L-2013-216  
10 CFR 52.3

Re: Florida Power & Light Company  
Proposed Turkey Point Units 6 and 7  
Docket Nos. 52-040 and 52-041  
Response to NRC Request for Additional Information Letter No. 072  
(eRAI 6985) - SRP Section 11.02 – Liquid Waste Management Systems

**NRC RAI Letter No. PTN-RAI-LTR-072 Dated February 20, 2013**

**NRC RAI Number: 11.02-6-5 (eRAI 6985)**

Figure 1 – Deep Injection Well (typical based on EW-1)

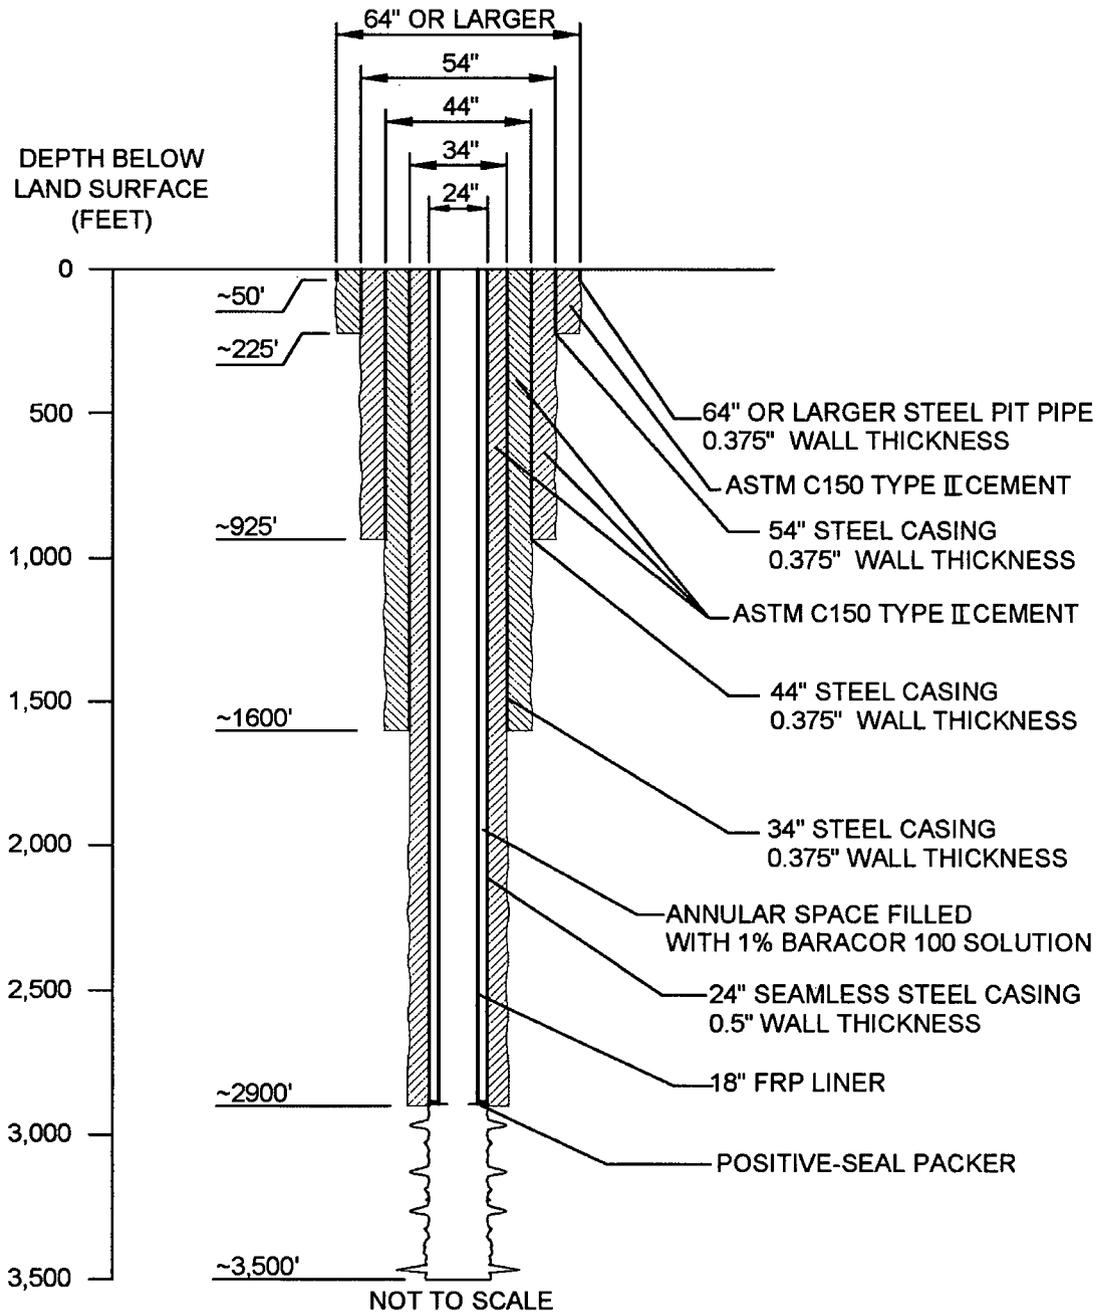
Since the deep injection well system will involve the use of 12 injection wells in relatively close proximity, the applicant is requested to address (1) a rise in pressure given the combined operation of multiple wells, and (2) potential fractures and formation of hydraulic connections, followed by upwelling into the above confining units. Regarding possible failures of well casings, the applicant is requested to describe design features of well casings and joints, and measures that will be implemented in ensuring the mechanical integrity of the injection and monitoring wells over their operational lives. In this context, the applicant is requested to describe plant operations and procedures should any upwelling or failures of the injection system be noted, and whether interim provisions will be made to use backup systems in disposing or storing of radioactive liquid effluents. The applicant should also describe well abandonment procedures, if needed during the lifetime of the license, including steps to confirm the mechanical condition of the wells, and methods and materials that would be used to plug and seal wells.

Each of the deep injection wells will be constructed with concentric steel casings to isolate and protect groundwater from injected fluid. Each injection well will be constructed with new and unused 64- (or greater), 54-, 44-, 34-, and 24-inch outside diameter steel casings designed to last for at least 60 years. The 64- (or greater), 54-, 44-, and 34-inch diameter casings will have a minimum wall thickness of 0.375-inches and conform to American Society for Testing and Material (ASTM) 139, Grade B specifications. The final 24-inch diameter casing will have a 0.5-inch wall thickness, will be seamless, and will conform to American Petroleum Institute (API) 5L specifications or ASTM 153 specifications. The well casings are selected to provide protection against casing failure during cementing operations, protect against failure during operation of the well and subsequent pressure tests, and provide sufficient corrosion protection. The 54-, 44-, and 34-inch diameter casings will be encased in cement on both the outside and the inside of the casing to protect against exposure to groundwater. The outside of the 24-inch diameter casing will be encased in cement to protect against exposure to groundwater. A nominal 18-inch diameter fiberglass reinforced plastic (FRP) injection tubing with a wall thickness of 0.76-inches will be installed inside the 24-inch diameter casing to protect the 24-inch diameter casing from exposure to injected fluids and subsequent corrosion. The annular space between the 24-inch diameter casing and the FRP injection tubing will be filled with a non-hazardous corrosion inhibitor (e.g. one percent Baracor 100 solution) and sealed at the base and top to create a pressure-tight annular space. Thus, each steel casing is either fully encased in cement or, for the 24-inch diameter casing, the outside of the casing is encased in cement while the inside of the casing is protected by a corrosion inhibitor. Figure 1 depicts a typical deep injection well. This schematic is based on the actual subsurface conditions encountered during the installation of exploratory well EW-1.

The cement bond log will be performed from the base of the 24-inch diameter casing to land surface and will be used to identify the presence of poor cement bonding with casing and/or formation. The uppermost 200 to 400-feet of the 24-inch diameter casing will then be cemented to land surface. Following completion of cementing the 24-inch diameter casing of each deep injection well in place, the casing will undergo a video inspection by lowering a submersible video camera down the inside of the casing to verify the absence of features that could potentially negatively impact the mechanical integrity of the well. The 24-inch diameter casing will also undergo pressure testing at a minimum pressure of 150 pounds per square inch (psi) prior to installation of the nominal 18-inch diameter FRP injection tubing.

Figure 1 – Proposed Locations of Deep Injection Wells and Dual Zone Monitoring Wells

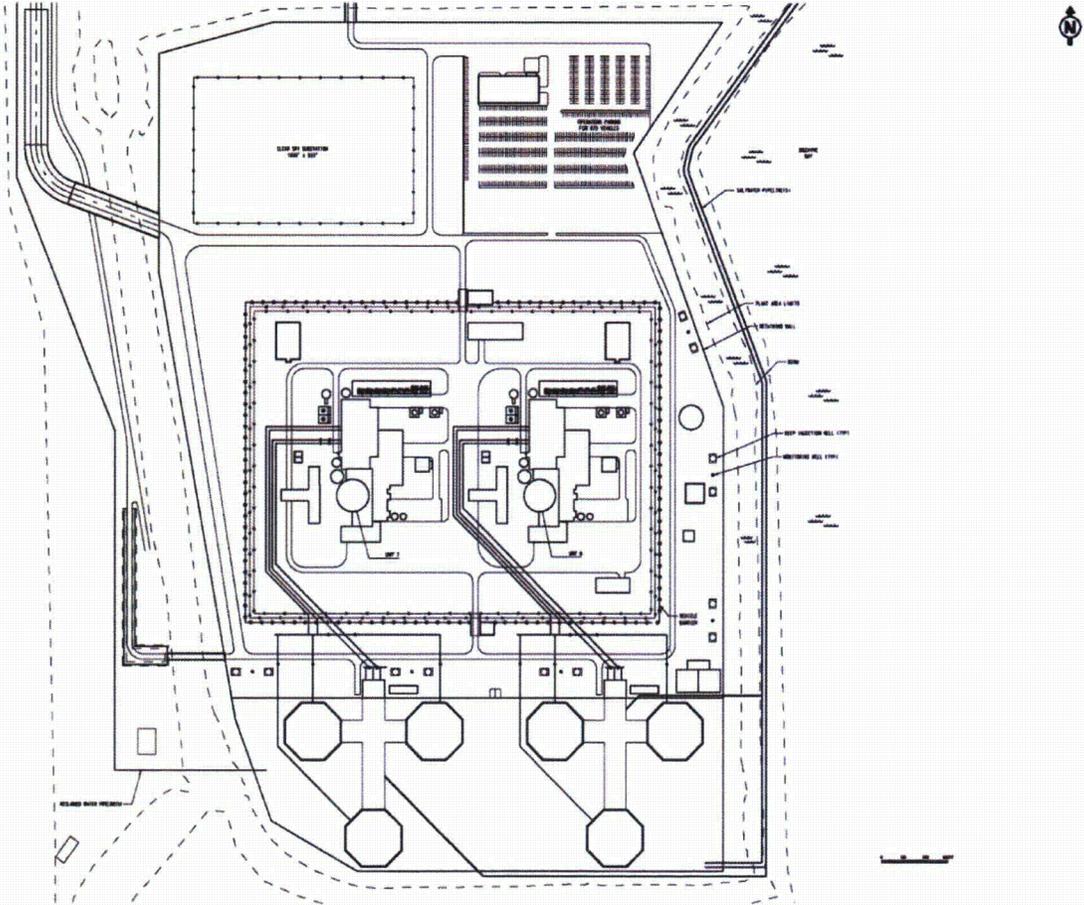
With respect to injection flow and dilution flow rates, the applicant is requested to reconcile differences in stated flow rates and citations for the location of such information. For example, FSAR Tier 2, Rev. 4, Section 11.2.3.5 refers to FSAR Section 9.2.6.2.1 for details on deep injection well, but this FSAR section addresses the treatment of sanitary wastes. While FSAR Tier 2, Rev. 4, Section 11.2.3.5 identifies dilution flow rates for the disposal of liquid effluents by deep injection well in assessing radiological impacts, it does not refer to a specific FSAR section for design specific information, such as FSAR Tier 2, Section 9.2 or 10.4.5. A review of ER, Rev. 4, Section 5.2.3.2.4 indicates that the stated flow rates are 12,500 gpm and 58,000 gpm, which are consistent with ER Rev. 4, Table 3.3-1 under normal and maximum cases. However, FSAR Rev. 4, Section 2.4.12.2.1.3 refers to peak and operational injection rates, with a stated 14,000 gpm for reclaimed water and 62,500 gpm for seawater as implied normal operational flow rates. These injection rates are driven, in part, by FLDEP specifications on maximum linear velocities and friction loss and injection pressures, but such details and limitations on the design basis are not described in the FSAR. Accordingly, it is not clear which injection flow rates form the FSAR design basis, and whether the stated injection flow rates reflect the information presented in FPL's September 2012 report on the construction and testing of the first exploratory well. The applicant is requested to review and revise the FSAR and include in its revision a description of the DWI system and flow schematics, essential operational features and characteristics, and design basis of deep injection well flow rates when using reclaimed water and seawater and qualify the operational conditions for each, as expected normal operation versus peak or maximum conditions, and their justifications in modeling radiological impacts.

There are two sources of makeup water for the circulating water system (CWS) – reclaimed water (primary) and saltwater from the radial collector wells (backup). The saltwater backup source is expected to be used not more than 60 days per calendar year. The deep injection well flow is comprised of the blowdown from the cooling tower circulating water system, additional dilution from the Reclaimed Water Treatment Facility (primary source only) and discharge flow from the sanitary waste treatment plant
